A RESOLUTION CONDITIONALLY APPROVING A 2 LOT CERTIFIED
SURVEY MAP, BEING PART OF THE NORTHEAST 1/4 AND THE
NORTHWEST 1/4 OF THE SOUTHEAST 1/4 OF SECTION 21, TOWNSHIP
5 NORTH, RANGE 21 EAST, IN THE CITY OF FRANKLIN,
MILWAUKEE COUNTY, WISCONSIN
(HORIZON RESOURCE GROUP LLC, APPLICANT)
(APPROXIMATELY 9150 SOUTH 80TH STREET)

Re: Horizon – Franklin 2 Lot CSM

We have revised the Certified Survey Map, Natural Resource Protection Plan and Site Engineering Plans based upon review letters from Milwaukee County, Franklin Engineering and Franklin Planning as noted below.

HORIZON - FRANKLIN 2 LOT CSM
 CITY OF FRANKLIN, WISCONSIN
NATURAL RESOURCE PROTECTION PLAN

S:\5166313\dwg\
CS120L15.dwg/SHEET 2

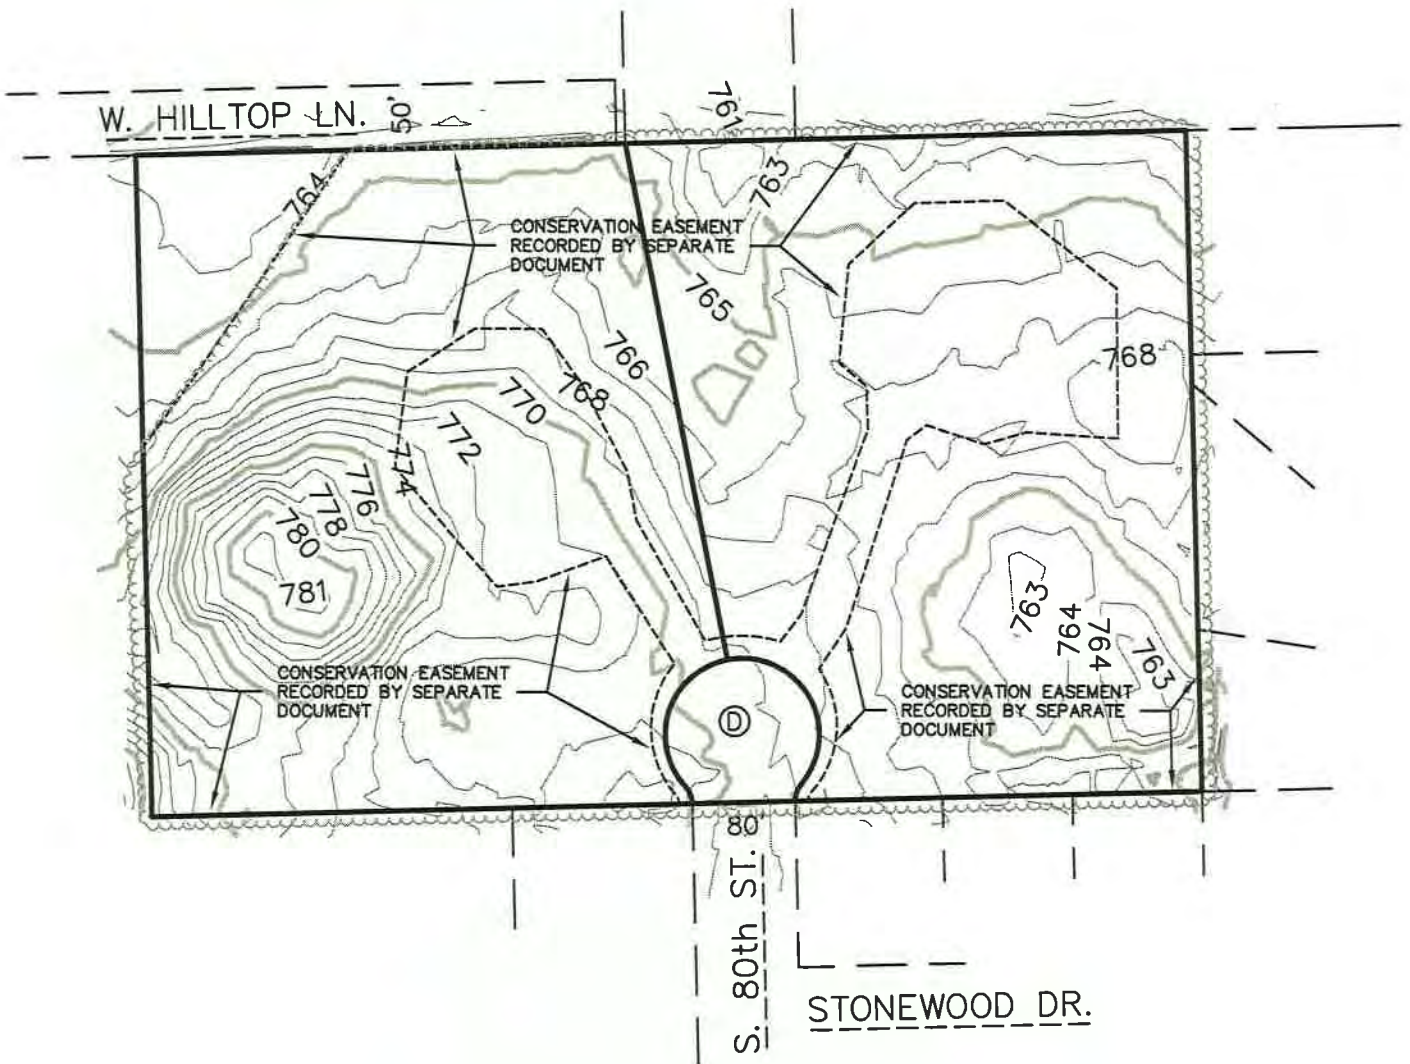
- *Show the phrase “Land is served by Sanitary Sewer and Water”.*

CSM (sheet 2) has been revised to include the above note.

HORIZON - FRANKLIN 2 LOT CSM
 CITY OF FRANKLIN, WISCONSIN
 SANITARY SEWER & WATER MAIN
 PLAN AND PROFILE

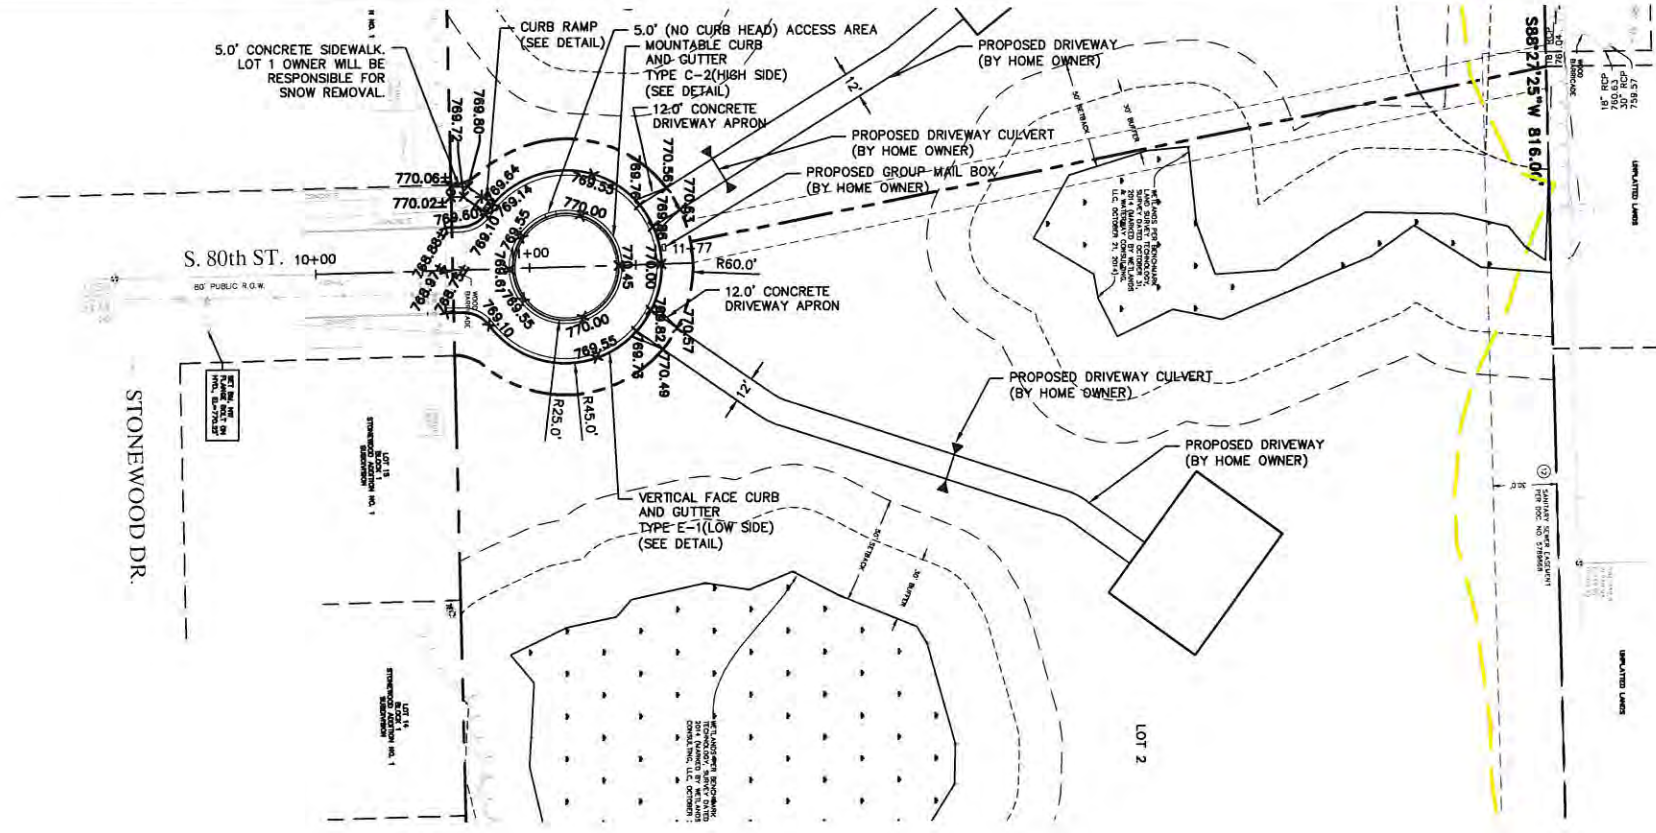
- ***Extend the existing water main, approximately 130' in length to meet the location of the proposed water main easement that runs in between the two lots.***

- ***Submit a plan and profile for the proposed extension of water and sewer.***

The proposed water main extension has been revised as requested.

A plan and profile for the proposed sanitary sewer and water main extension has been added as requested.

HORIZON - FRANKLIN 2 LOT CSM
 CITY OF FRANKLIN, WISCONSIN
 PAVING
 PLAN AND PROFILE

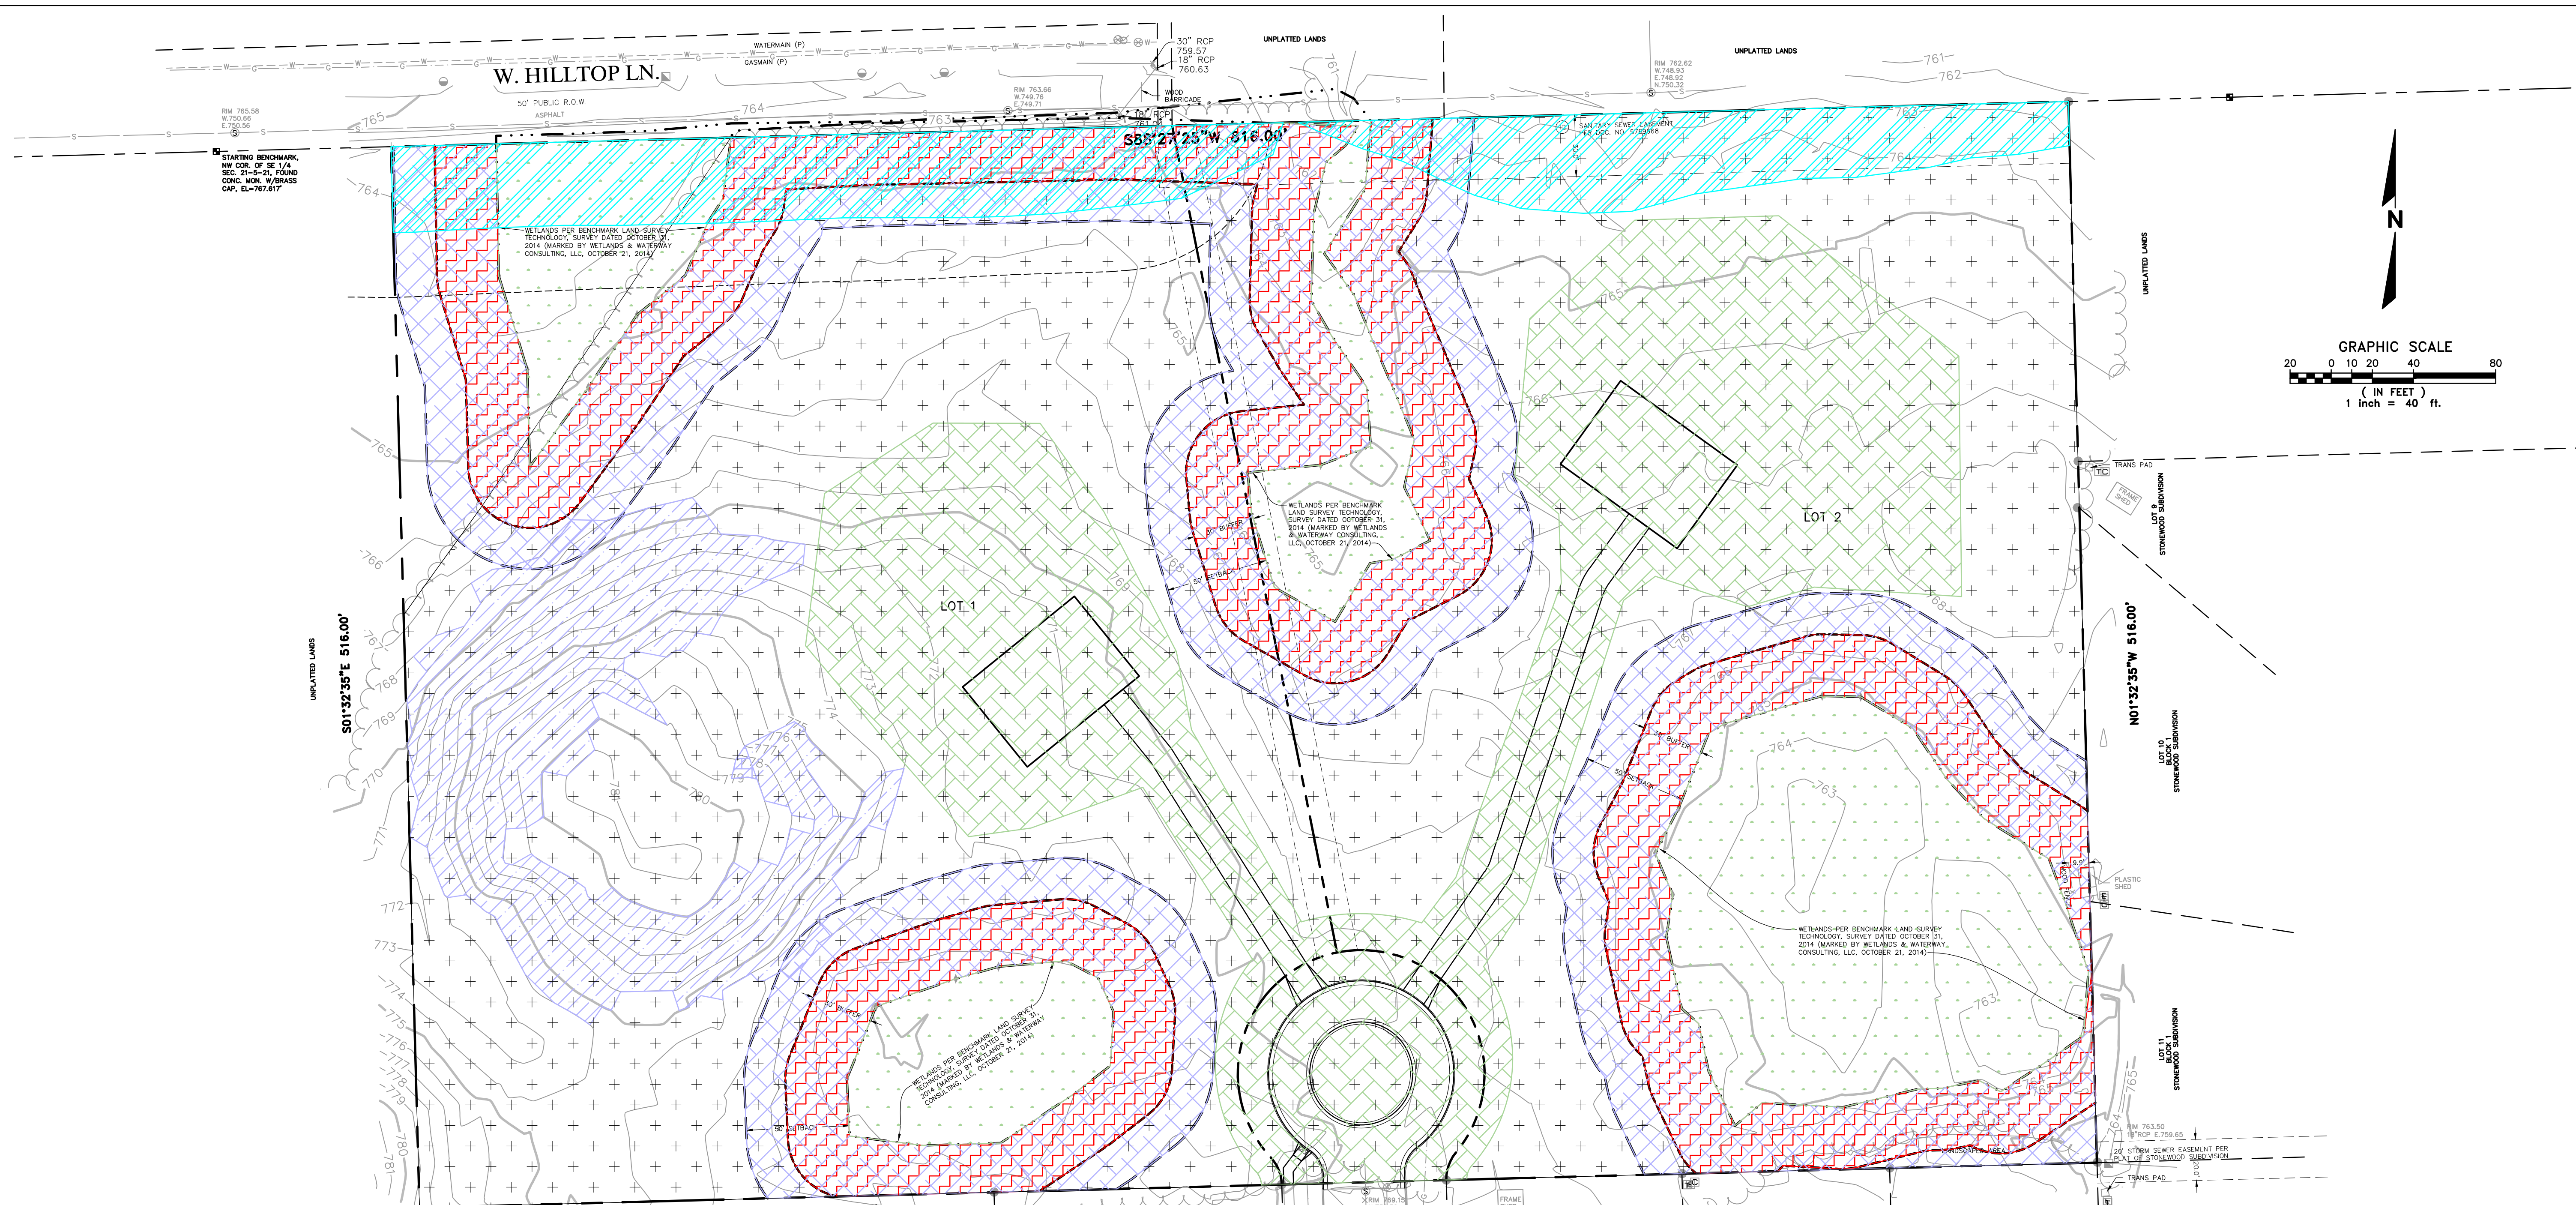
- ***Extend the existing 5' sidewalk for both lots. Must meet the UDO Section 15-5.0103.***

- ***Design cul-de-sac in accordance with technical memorandum dated 5/24/13.***

The existing sidewalk has been extended into Lot 1 and a ramp has been added to connect the cul-de-sac. We understand that the owner of Lot 1 will be responsible for snow removal of this sidewalk.

The cul-de-sac has been revised in accordance with the desired engineering department standards.
